Access Compliance Report Public Rights-of-Way (Curb Ramps)

Main Street: STRAWFLOWER_ST		Cross Street: GILLY_FLOWER_ST		Location:	NW
ADA ID: RPAT211102134244	Ramp Type: Type 4 - Parallel	Initial Pass/Fail: Fail	Overall Compliance: No	Severity Score:	15
Codes/Mitigation Info/Possible Solution			Field Measurements/Component Compliance

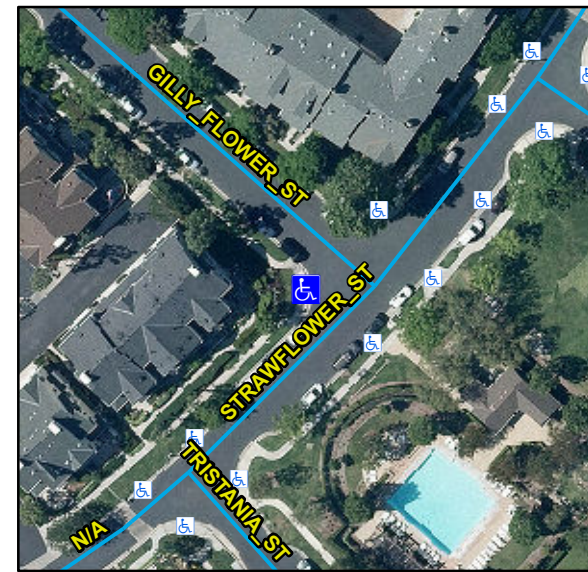
Compliance	Description	Data	Compliance	Description	Data
N/A	Ramp Length LT (in)	105	N/A	Ramp Length RT (in)	105
Yes	Ramp Width LT (in)	54	Yes	Ramp Width RT (in)	54
Yes	Ramp Run Slope LT (%)	5.5	Yes	Ramp Run Slope RT (%)	1.4
No	Ramp Cross Slope LT (%)	5.1	No	Ramp Cross Slope RT (%)	3.8
N/A	Landing Present	N/A	N/A	DWS Provided	N/A
N/A	Landing Length (in)	N/A	N/A	DWS Contrast	N/A
N/A	Landing Width (in)	N/A	N/A	DWS Length (in)	N/A
N/A	Landing Run Slope (%)	N/A	N/A	DWS Full Width	N/A
N/A	Landing Cross Slope (%)	N/A		DWS Offset Type	N/A
N/A	Landing Movement Obstructed?	N/A	N/A	DWS Offset Left (in)	N/A
	Landing Movement Type	N/A	N/A	DWS Offset Right (in)	N/A
N/A	Landing Shared	N/A			
N/A	Clear Space	Yes			
N/A	Clear Space To Crosswalk (in)	N/A			
N/A	Marked Crosswalk 1	No	N/A	Marked Crosswalk 2	No
	Crossing 1 Direction	SE		Crossing 2 Direction	NE
	Marked Crosswalk 1 Width (in)	N/A		Marked Crosswalk 2 Width (in)	N/A

Remove & Replace Curb Ramp With Two New Directional Ramps or Equivalent.
